Discussion Paper - Bradfield City Centre Masterplan Application

Amendments to Western Sydney Aerotropolis Precinct Plan and Development Control Plan.

October 2023

Plan Reference: Western Sydney Aerotropolis Precinct Plan March 2022 – Land Use and Structure Plan (Figure 3)

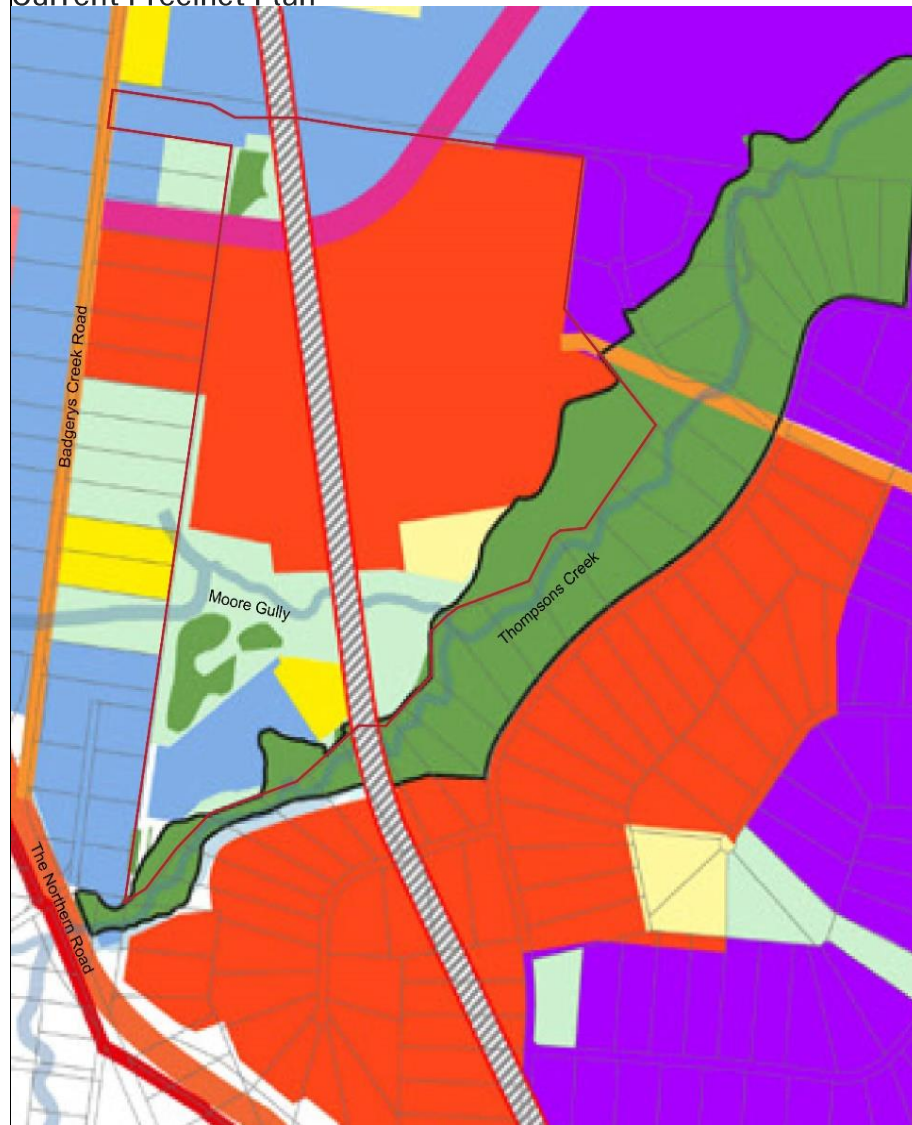
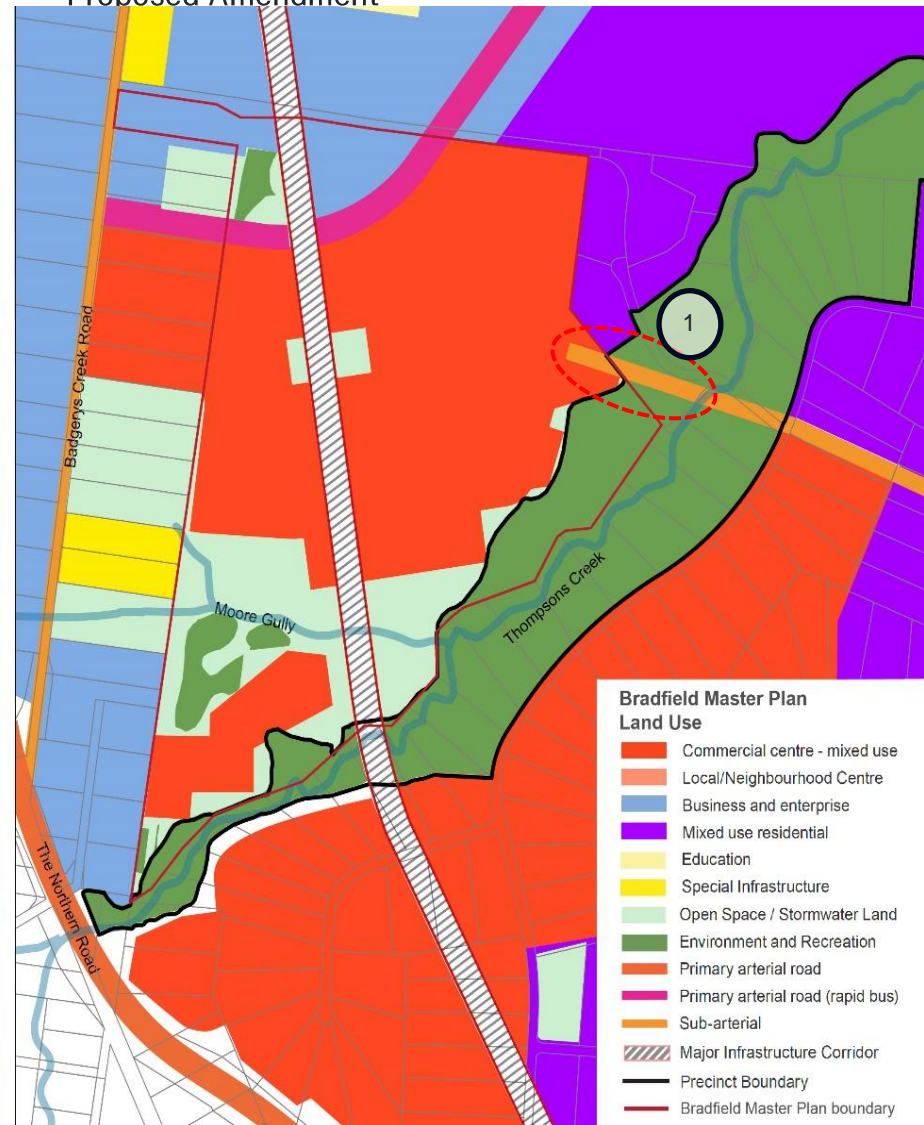
The Master Plan seeks to amend the Land Use and Structure Plan. These amendments will:

- Allow for the introduction of a new Central Park in the city centre.
- Amend the land use boundaries at the Thompsons Creek and Moore Gully interface to reflect the Master Plan Design for these areas.

- Amend the land uses in the southern area from 'Business and Enterprise' to 'Commercial Centre - Mixed use' and land uses in the eastern area (Whittaker Road intersection) from Mixed use residential to Commercial Centre. The proposed changes ensures that the entirety of the site has a commercial centre -mixed use land use which is consistent with the overall land use nominated for the site.

- Removes the specific location and size for the future school site within the 'Education' land use area. This provides greater flexibility in the future as the locations and timing of educational facilities are under investigation and subject to further review and due diligence by School Infrastructure NSW.

- The area that is denoted as 'Special Infrastructure' in the Aerotropolis Precinct Plan has been incorporated within the Mixed Use (MU) under the Western Parkland City SEPP and has been amended to reflect the 'Commercial Centre - Mixed use' which is included within the DPE LEP Practice Note.

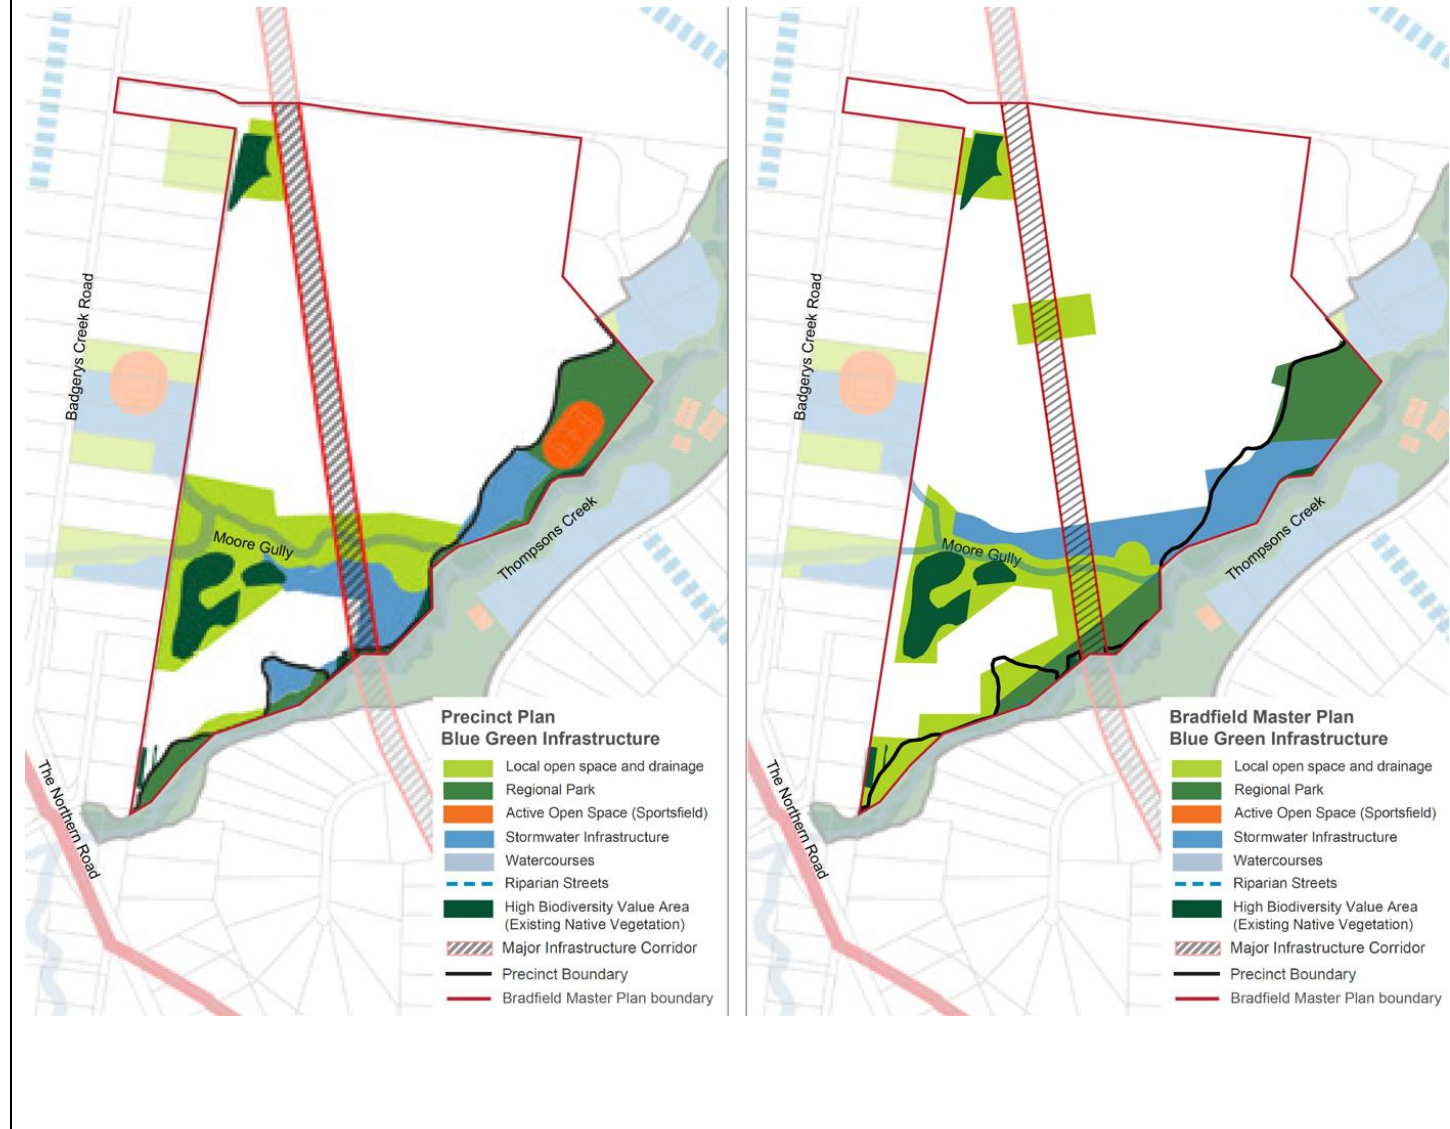
1. Whitaker Road has moved slightly south at the existing boundary of Lot 273 into land identified for acquisition purposes. As a result of the movement, there is currently no land use that applies to the site. It is recommended that the existing residential lot adopt a mixed-use residential land use. This is consistent with the existing land use.

Due to the realignment of Whitaker Road slightly south at the boundary, it is recommended that the small portion of land which is currently identified as sub – arterial road, be amended to adopt mixed-use residential land use. The recommended land use is entirely consistent with the land use nominated for the site and will not result in any negative impacts to the affected landowner.

Plan Reference: Western Sydney Aerotropolis Precinct Plan March 2022 – Blue – Green Infrastructure Framework (Figure 5)

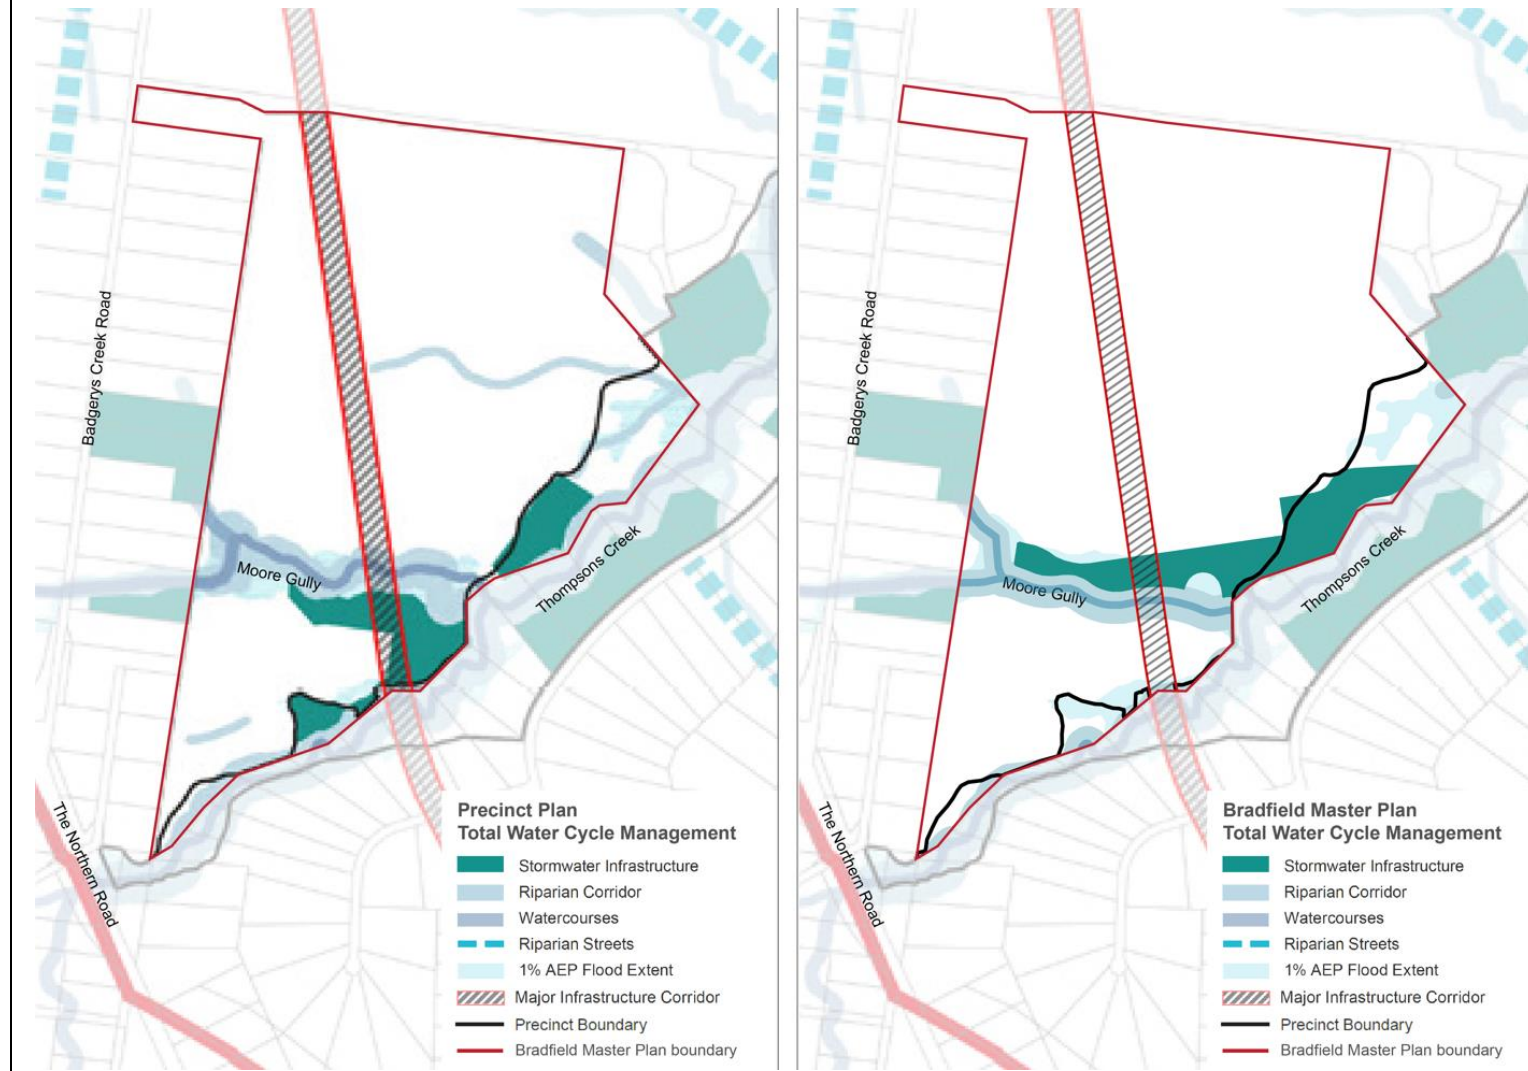
The Master Plan seeks to amend the Blue – Green Infrastructure Framework Plan. The amendments are required to reflect the Moore Gully realignment, stormwater areas and additional open space areas proposed in the Master Plan design.

Plan Reference: Western Sydney Aerotropolis Precinct Plan March 2022 – Total Water Cycle Management (Figure 6)

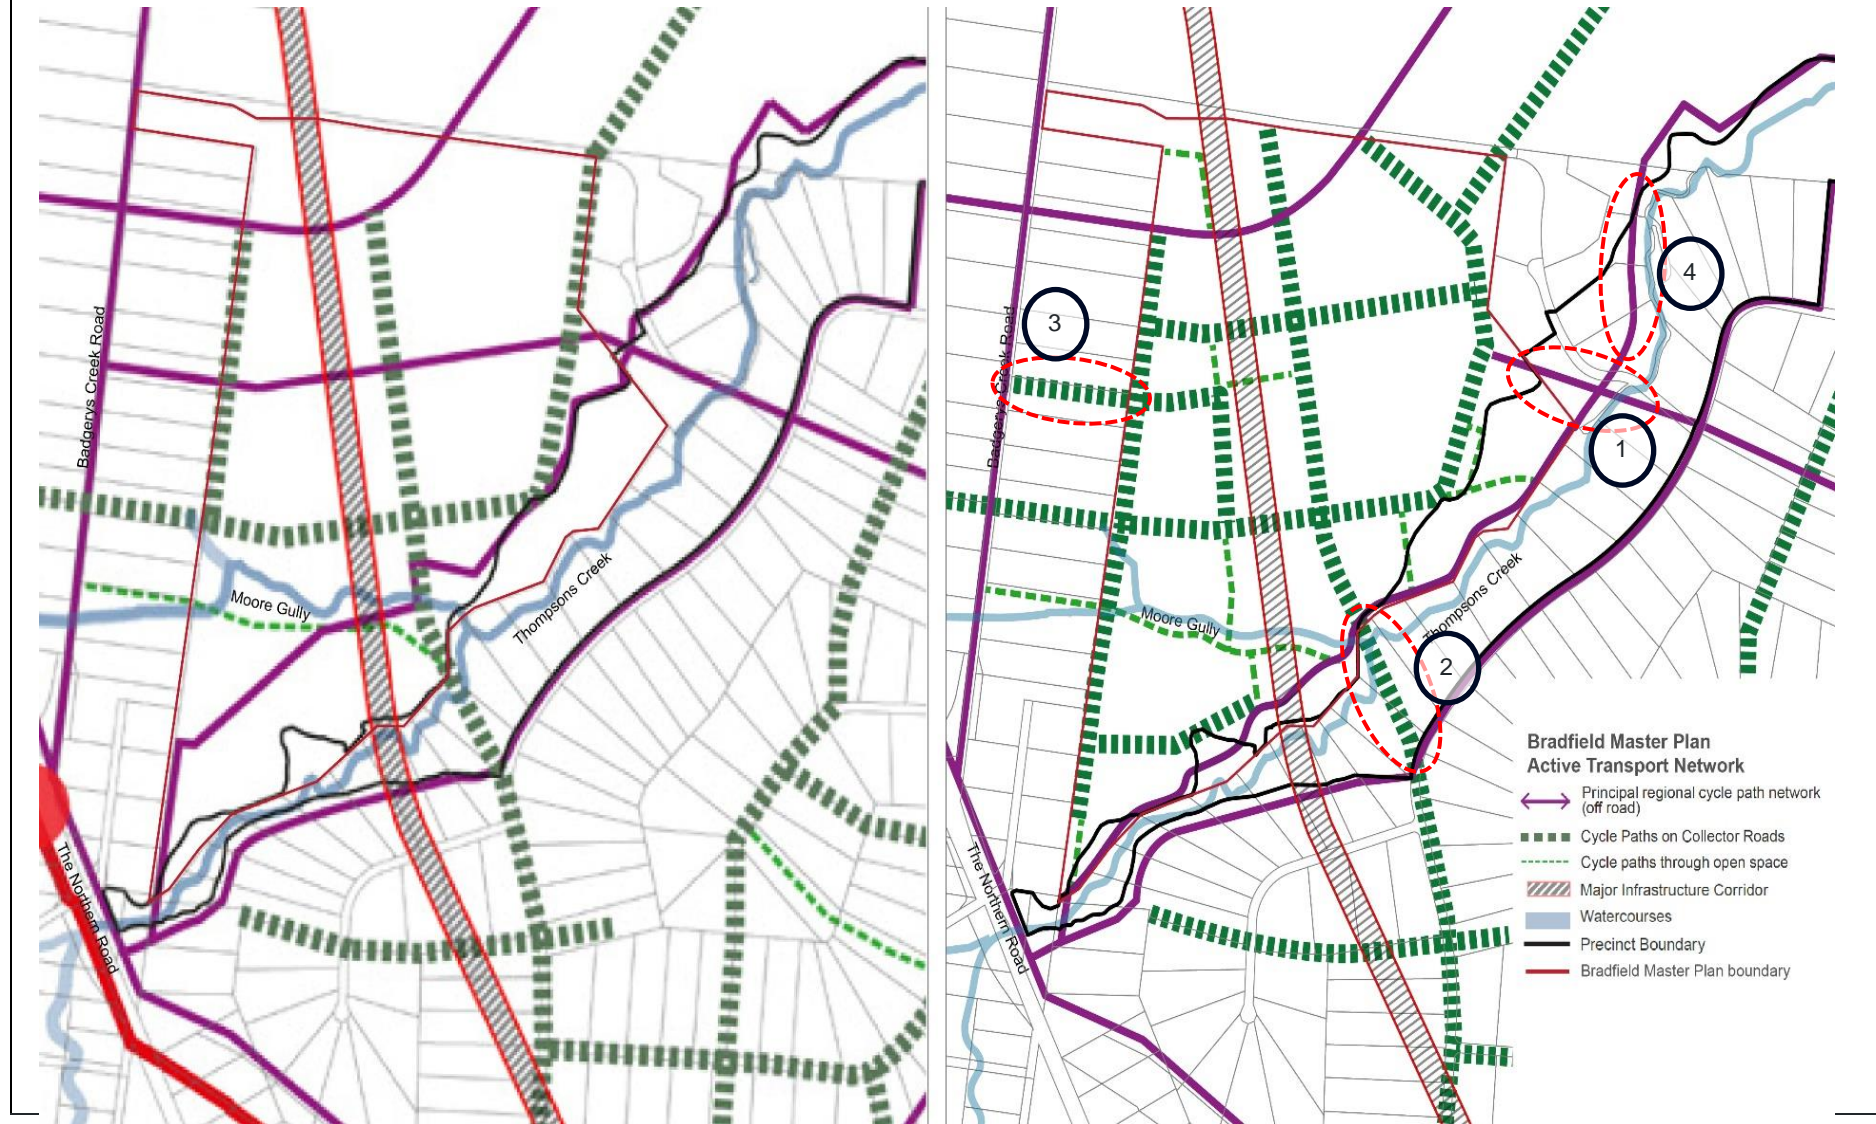
The Master Plan seeks to amend the Total Water Cycle Management Plan. The amendments are required to reflect the Moore Gully realignment and stormwater areas proposed in the Master Plan design.

Plan Reference: Western Sydney Aerotropolis Precinct Plan March 2022 – Street Hierarchy Plan (Figure 10)
 Current Precinct Plan Proposed Amendment

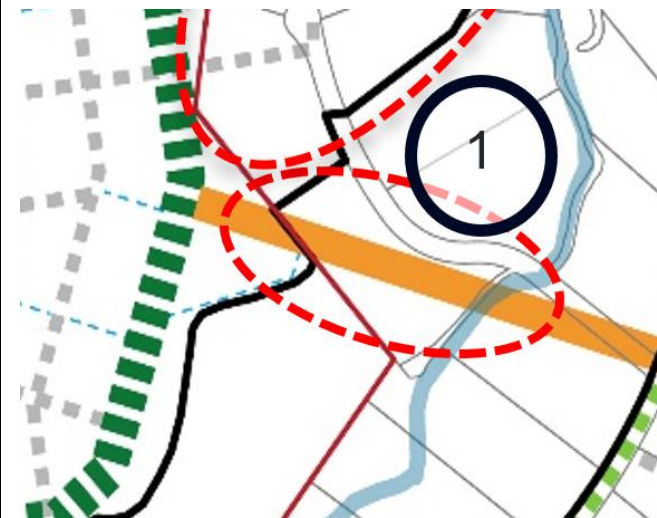
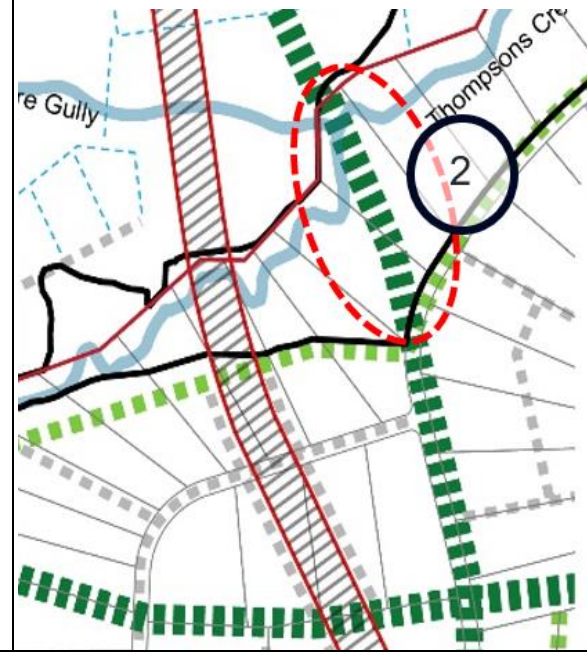
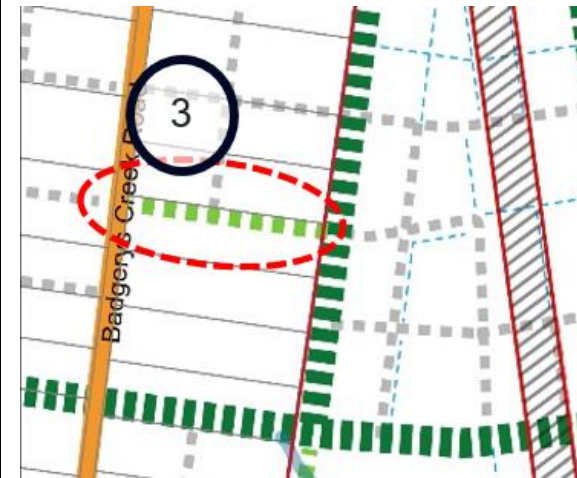
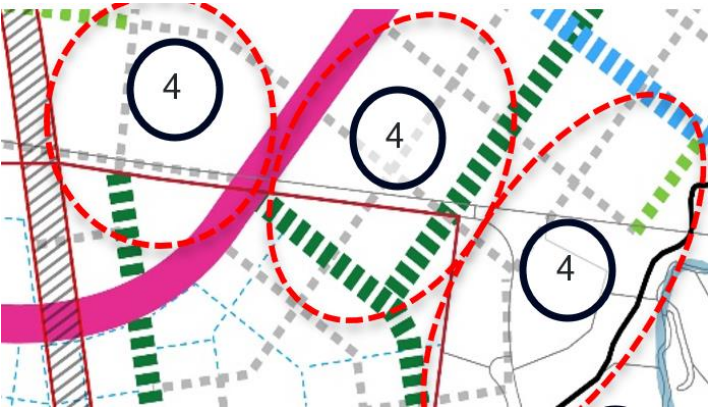
The Master Plan seeks to amend the Street Hierarchy Plan. The amendments propose the following changes:

- Amend the street network in line with the Master Plan design including re-alignment of Whittaker Road slightly south.
- Identify pedestrian-only and shared zone street types (City Lanes and Parklands Promenade).
- Provide direct connections from Central Park to Moore Gully and Thompsons Creek activity nodes.
- Amend the collector roads more direct connection between Whitaker Road and Metro Link Boulevard.
- Identify pedestrian connections across Moore Gully and Thompsons Creek regional park.
- Realigned the bridge over Thompsons Creek to the east slightly.

1. Whitaker Road has moved slightly south at the existing boundary of Lot 273 into land identified for acquisition purposes.

2. The Rapid Bus Corridor has moved east slightly at the boundary to reduce bridge span over one creek rather than two which will reduce impacts and costs.

3. Park Edge Street moved south slightly into land identified for acquisition purposes.

<p>4. Indicative Local Streets identified as grey on the Plan have been slightly realigned to match the proposed road network in the Master Plan. The realignments ensure that regular blocks, intersections, and future access to and from the site is provided. The future location of Local Streets is indicative and subject to future development applications.</p>	
<p>Justification</p> <p>The proposed re-alignment of Whittaker Road is not considered to have any negative impacts on the adjoining landowners. Whittaker Road has been moved slightly south at the existing boundary of Lot 273 into land identified for acquisition purposes in the SEPP. Land acquisition will be undertaken by the relevant authority and subject to Thompsons Creek Regional Masterplan.</p> <p>The proposed re-alignment of the Rapid Bus Corridor is not considered to have any negative impacts on adjoining landowners and will result in a better outcome as it will reduce the bridge span over one creek instead of two. The Rapid Bus Corridor is contained within land identified for acquisition purposes in the SEPP.</p> <p>The proposed re-alignment of the Park Edge Street is not considered to have any negative impacts on the adjoining landowners. On the contrary it will increase the amount of developable area for the private landowner. The Park Edge Street has moved slightly south at the existing boundary of Lot 273 into land identified for acquisition purposes in the SEPP.</p> <p>The proposed re-alignment of indicative Local Streets is not considered to have any negative impacts on the adjoining landowners. Whilst the realignments ensure that regular blocks, intersections, and future access to and from the site is provided, the future location of Local Streets are indicative and subject to future development applications.</p>
